NOTICE:

As a result of a temporary parts shortage, the 4-position slide switch used for range selection has been replaced with a 5-position slide switch in a limited period of production runs. See pages 3-4 for details.

PWR Series

Wet Media Remote Pressure Transducer

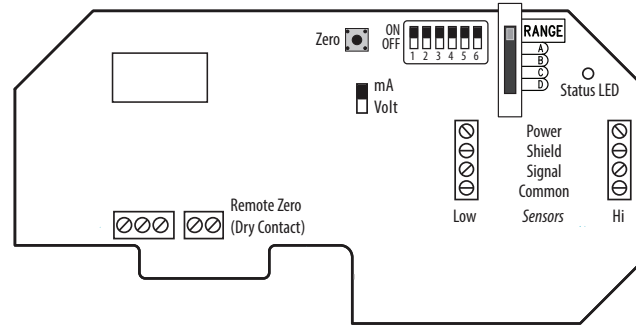
As a result of a temporary parts shortage, the 4-position slide switch used for range selection has been replaced with a 5-position slide switch in a limited period of production runs. This will have a minor impact on how the range selection works on the affected models. The 5-position switch will be used in models produced between these dates:

The extra (fifth) position will align with the "RANGE" text printed on the product PCB. When this position is selected, the product will treat this the same as if range "D" is selected.

- Look at the date code printed on the product label. If the date code falls between the starting date and ending date listed above, inclusive of those values, then the product will have a 5-position range switch.
- Look at the range selection switch. The switch body will extend slightly beyond the edge of the PCB.

Model	Range (PSI)				
	Extra	A	B	C	D
PWRxx03	5	50	25	10	5
PWRxx04	10	100	50	20	10
PWRxx05	25	250	125	50	25
